**DATE:** April 3, 2024  
**TO:** Franklin Planning Board  
**FROM:** Department of Planning and Community Development  
**RE:** 6 Forge Parkway  
Site Plan

**Re: 6 Forge Parkway  
Site Plan Peer Review**

**A&M Project #:** 1362-25  
**Re:** 6 Forge Parkway  
Industrial Building  
Response to  
Review Comments

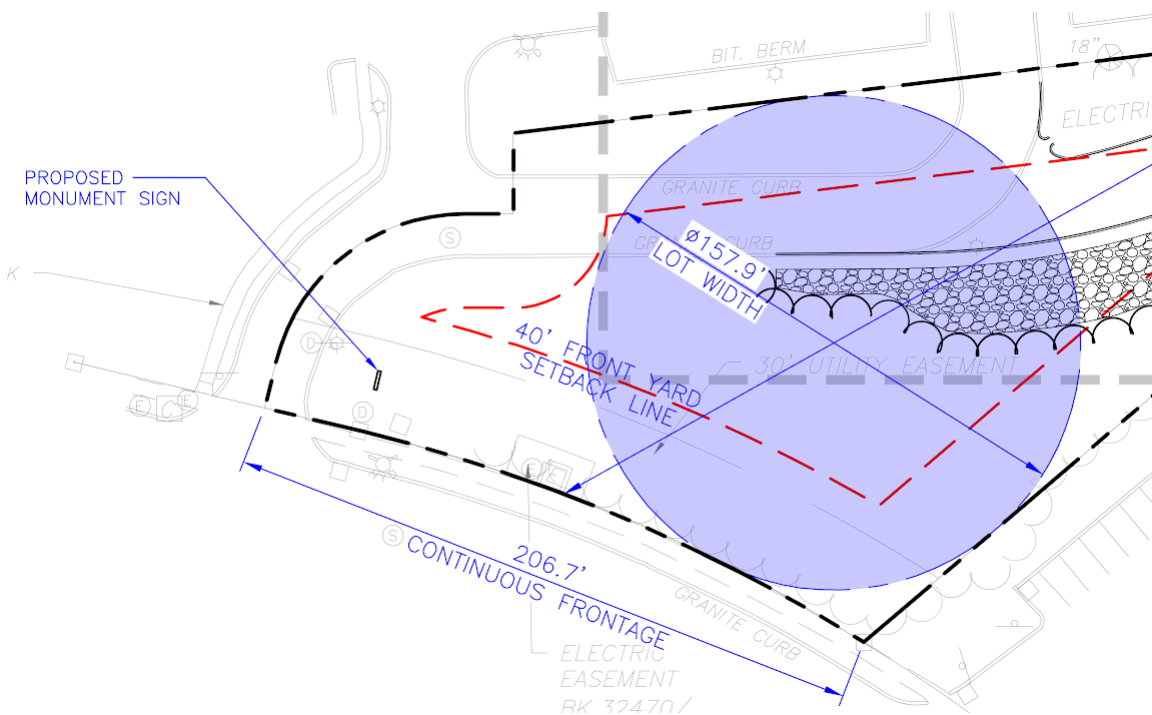
In anticipation of our upcoming planning board hearing, I wanted to follow up to the discussions that we had at our last board hearing in February. It appears that there was some misunderstanding regarding the conformity of our site as it relates to the current zoning requirements. Specifically, the 'Minimum Lot Width' which by definition is *"the diameter of the required circle, placed between the side lot lines and tangential to the frontage of a given lot"*. Unfortunately, our plans had this incorrectly stated in the zoning table which may have led to some of the confusion. The excerpt below is from the attached updated site plan showing that the minimum 157.5' circle can fit within the parcel limits.

Below is an excerpt from the updated site plan which better illustrates that the existing parcel is in conformity with the zoning ordinance.

Image 1 - View looking southwest, towards the development, from Route 140, Source: Google Maps

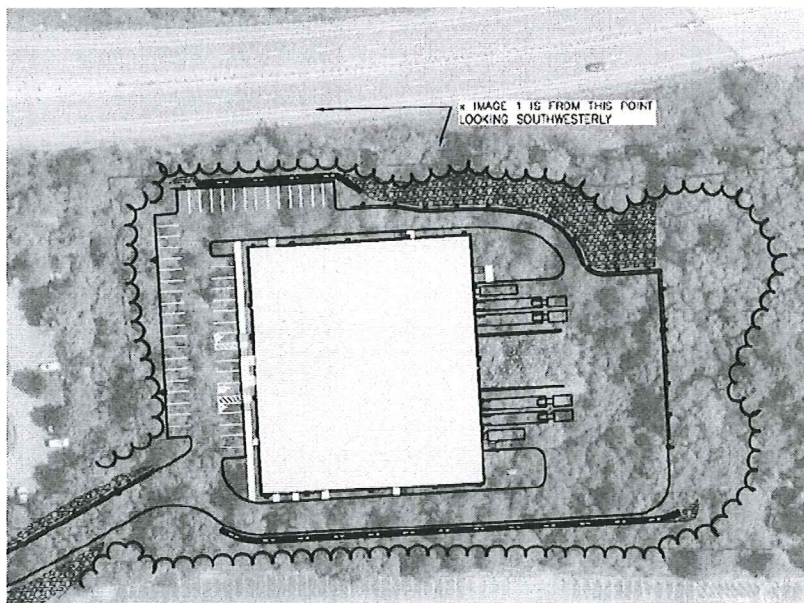
Based upon the 2021 Aerial imagery available it is difficult to determine if the vegetation along route 140 is sufficient to screen the loading docks from view from the roadway. In addition, because of the steep grades to the floor of the valley from the loading docks area will be covered in riprap without any vegetation. BETA recommends that the applicant provide additional information to the Board to allow that determination to be made.

**A&M Response:** Based on available aerial and street view imagery, it appears that a substantial vegetated berm exists and will separate and screen the development from Route 140. See Images 1 and 2 below.
